Harbourside

## Extended Construction Hours Construction Noise and Vibration Management Plan Addendum

Project ID	20250483.10
Document Title	Extended Construction Hours Construction Noise
Attention To	Mirvac Constructions Pty Ltd

**Figure 5: Updated Crane Dismantling Works – Vehicle Movements**

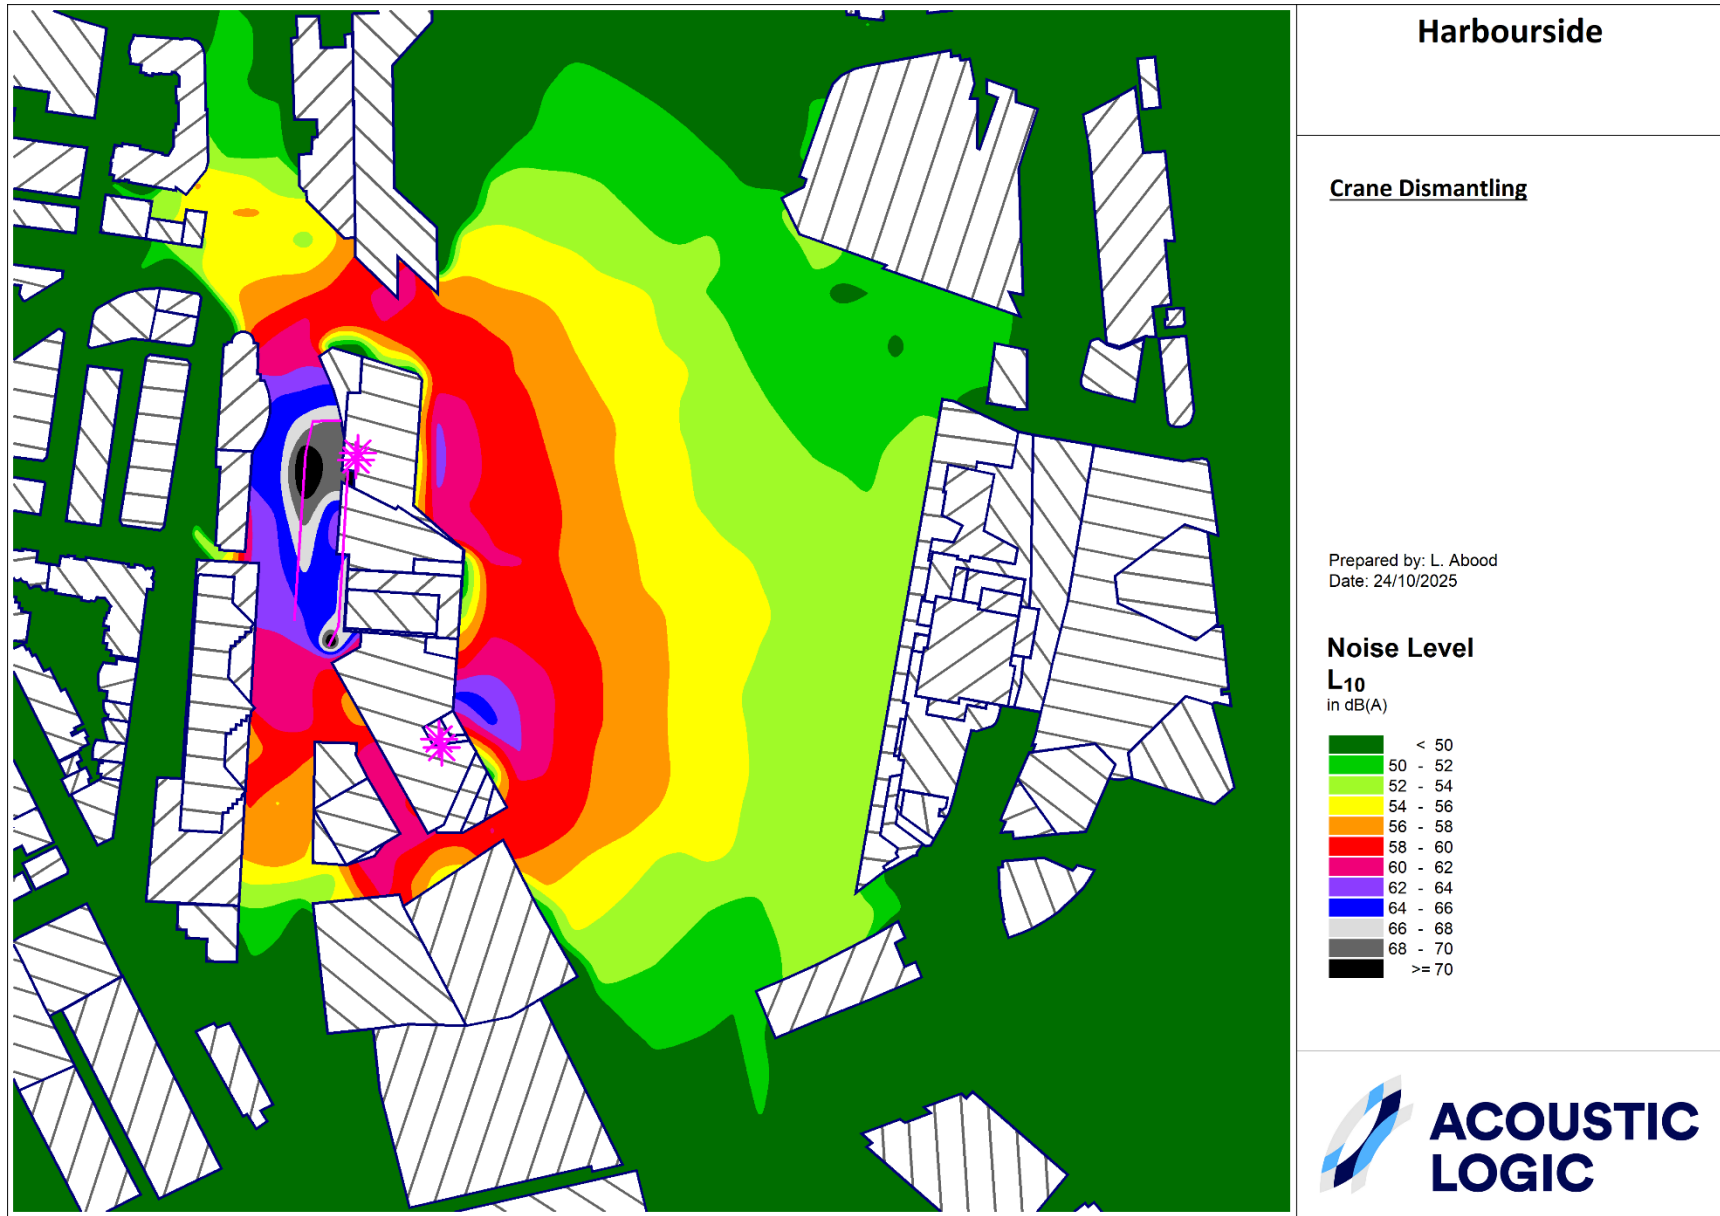
*Confirm that the acoustic assessment has considered the vehicle movements of construction vehicles associated with the activities (noting that construction vehicles include the delivery of materials to and from the site and the like, not just the use of vehicles such as excavators). The Department supports use of the internal basement but notes this may not be feasible for all works such as crane dismantling etc.*

- Among the remaining works packages assessed within the Extended Hours CNVMP, the only works package which is expected to include deliveries or materials handling during an OOH works period which is not within the basement carpark / loading dock area would be the crane removal works.

- The modelled scenario of the crane removal works has been updated below to include an assumed worst-case load of one articulated vehicle movement within a given 15-minute period.

- Notwithstanding, the results of this updated scenario are provided below and summarised within the following table for reference.

Receiver	Crane Removal		Comments
	Predicted External Noise Levels	Noise Management Level	
	dB(A) L <sub>10(15 min)</sub>		
R1	≤ 62	≤ 59	Predicted noise levels in line with Extended Hours CNVMP Crane Removal modelling, no further mitigation measures required.
R2	≤ 50		
R5	≤ 60	≤ 56	
R6	≤ 61	≤ 59	
R7	≤ 64		
R8	≤ 65	≤ 56	
R12	≤ 52	≤ 65	
R13	≤ 54	≤ 59	
R14		≤ 65
